Docket No. 52-010

Subject: **Response to NRC Request for Additional Information Letter No. 172 Related to the ESBWR Design Certification – Safety Analyses – RAI Number 15.0-2S02**

**Response to Portion of NRC Request for
Additional Information Letter No. 172
Related to ESBWR Design Certification Application**

RAI Number 15.0-2 S02

Figure 15.1-23. Event Diagram – Control Rod Withdrawal Error During Refueling

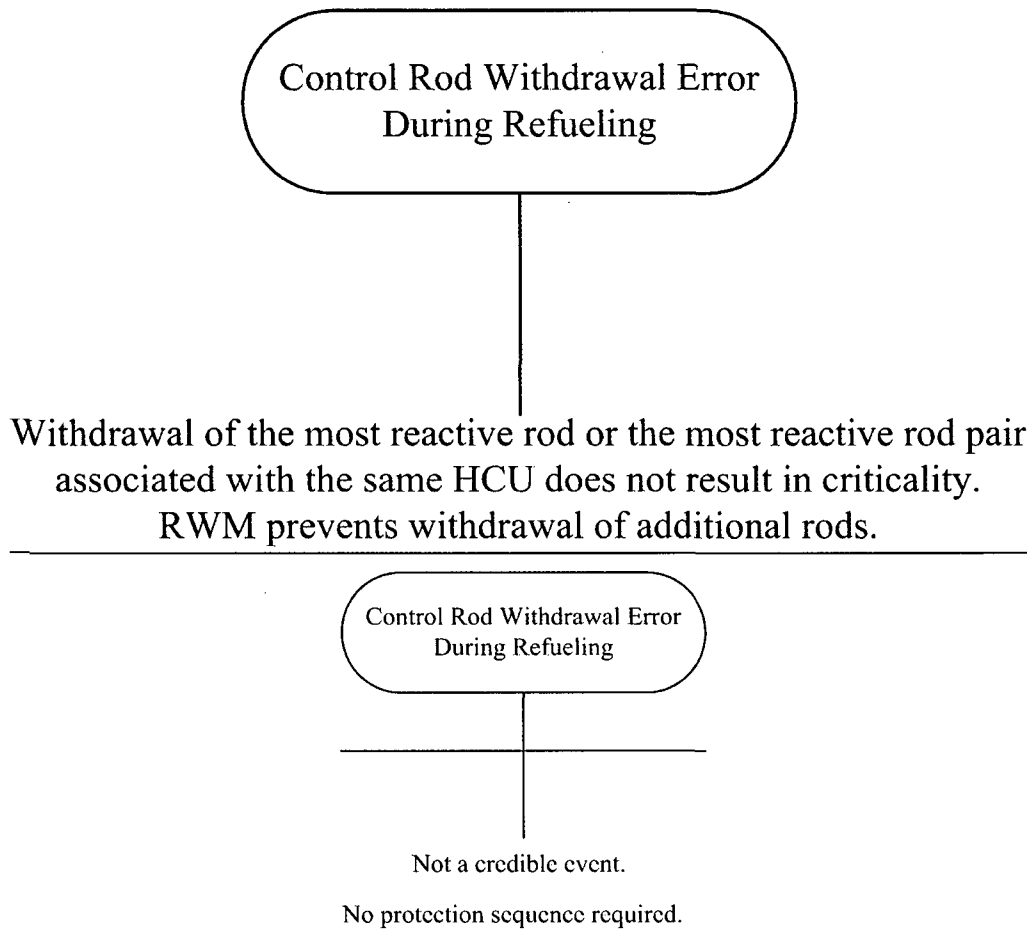
(b) It is our understanding that credit is taken for Rod Worth Minimizer (RWM) in Chapter 15 analyses.

Add RWM to Table 15.1-6 and add a Note 1.

(b) The Rod Worth Minimizer (RWM) is credited in the control rod withdrawal error during a refueling event. The RWM is also credited in the Rod drop accident event. Table 15.1-6 is updated to include the RWM for both of these events.

DCD Tier 2, Table 15.1-5, Table 15.1-6 and Figure 15.1-23 will be revised as noted on the attached markup.
